TITLE SERVO, X+O CHANGING			PIB NO. DK3066	
PRODUCT LINE:	TAPE DISK FORMATTER X	EQUIPMENT CHANGED N/A	MODEL SERIES AFFECTED D3000	EFFECTIVE DATE 2/15/77

To minimize deflection of the Lamp and Lens Assembly P/N 103499-01.

(FIGURE 1)

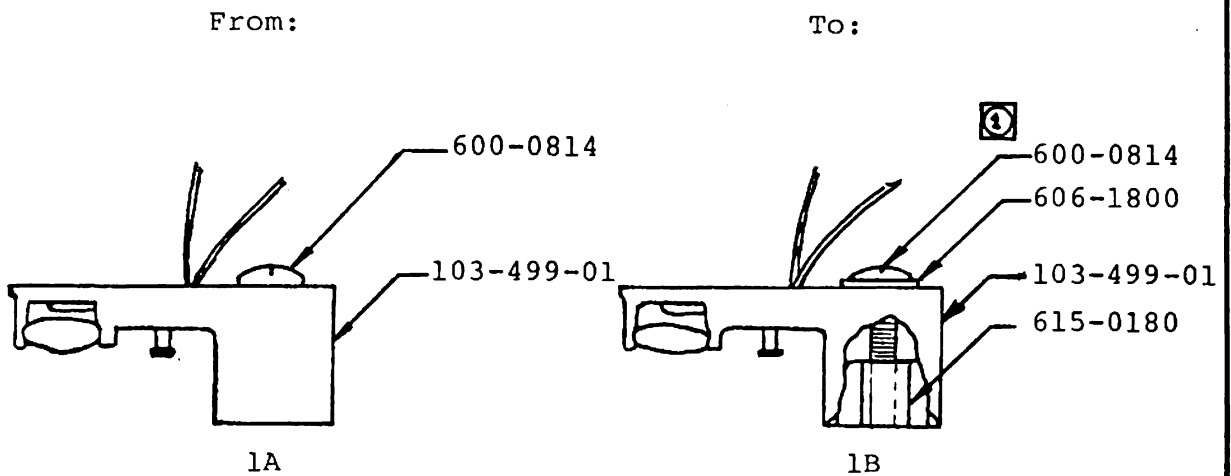
Loose Lamp and Lens Assembly, resulting in gain change of X+O signal.

1. Remove Lamp and Lens Assy - exercise caution as not to scratch the Glass Scale Assembly.
2. Remount the Lamp and Lens Assembly with the spacer P/N 606-1800 inside the body. (See Figure 1B).
3. Install screw (8-32x7/8) with #8 washer (P/N 606-1800)
4. Tighten screw to 10-15 inch pounds (or tighten until SNUG plus 15°, if Torque Wrench is unavailable).
5. Insure that the Sensor Receiver Assembly (A.K.A. Reticle) to Scale clearance is .005 ± .001 inch, by adjusting the post height with the screw located in the center of the post.

① Torque 10-15 inch pounds.
